Building Code Capability Statement

Mixed Use Development
469-483 Balmain Road, Lilyfield NSW

Prepared for Roche Group Pty Ltd

22 May 2023

Figure 8: Drawing No DA601, Revision 01, Material Palette, prepared by CHROFI

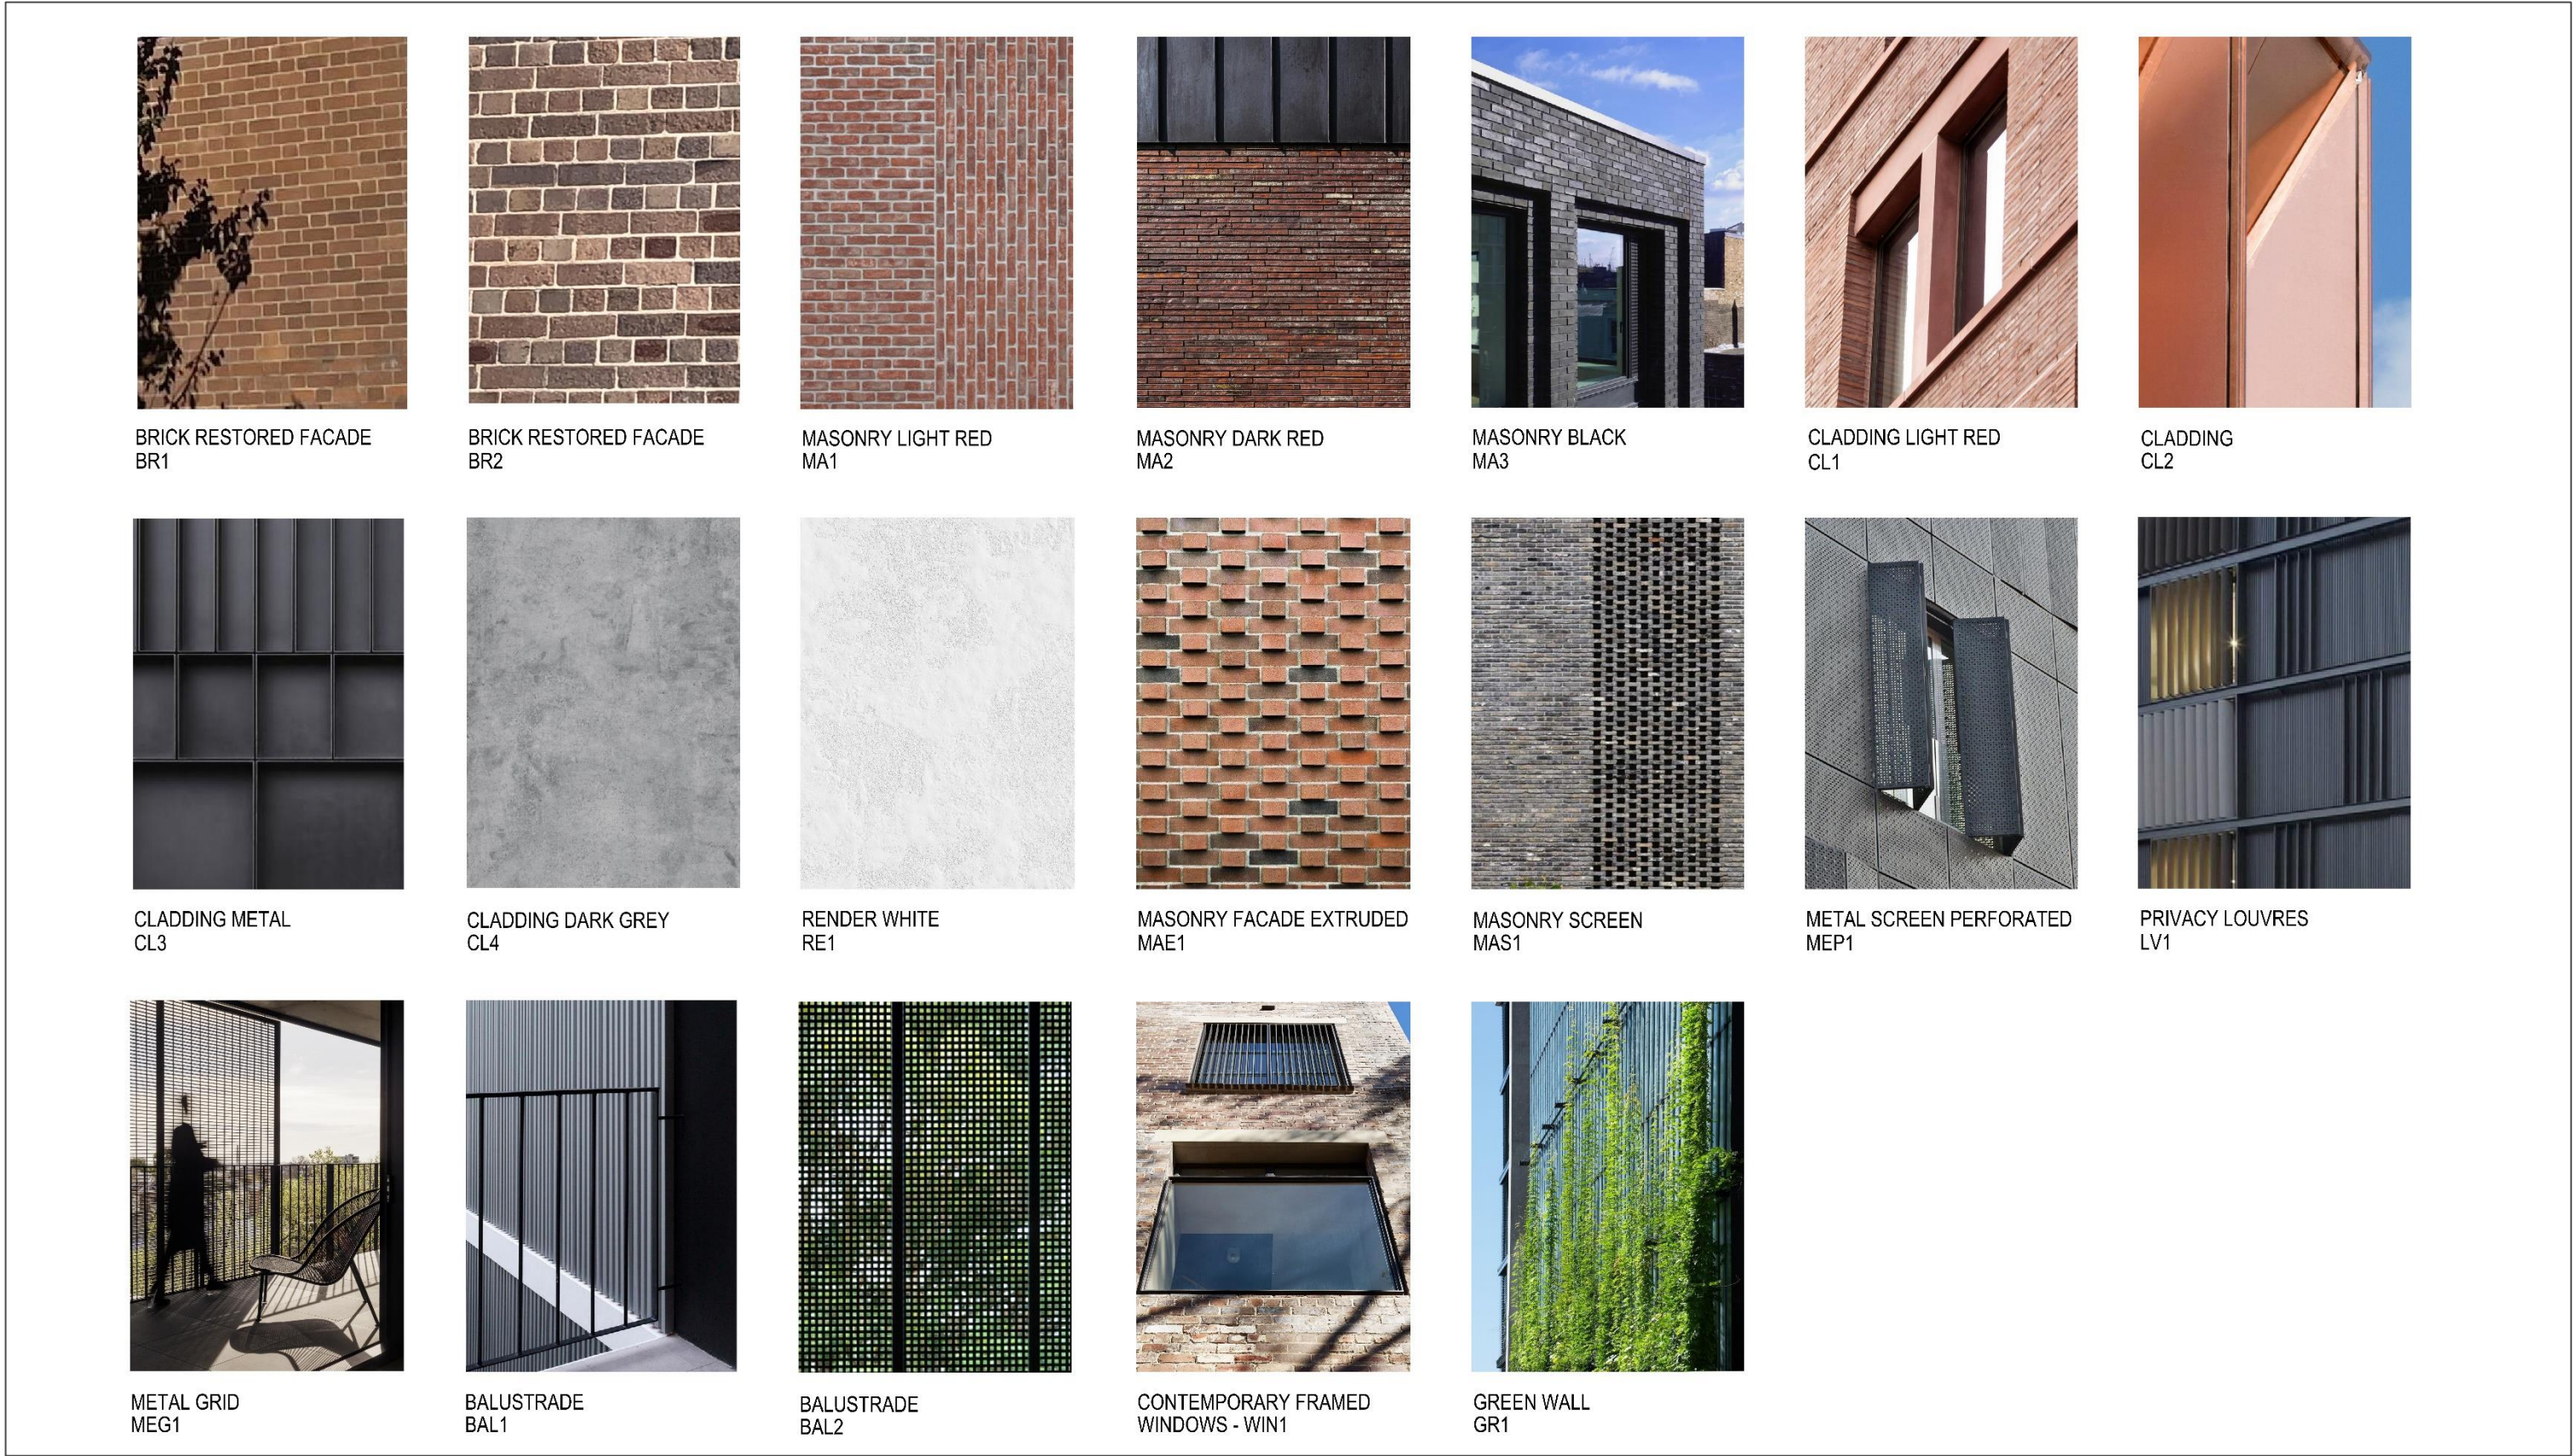
8.	C2D14 Green Wall forming an attachment to external walls	A Green Wall (referred to as 'GR1' in the Material Palette in Drawing No. DA601) is proposed as part of the development, and will need to be addressed in the FER, noting that: - These systems typically comprise lightweight interlocking panels (forming the structure of the Green Wall that attaches to the external wall(s) of the building) and are either constructed from plastic or contain plastic components e.g. planting beds/trays; and - In addition to the combustible elements forming the green wall structure, further combustible materials including organic material (soil, plants etc.) along with geotextile fabrics for filtration and flexible pipework for irrigation are also expected to be used	C1P2
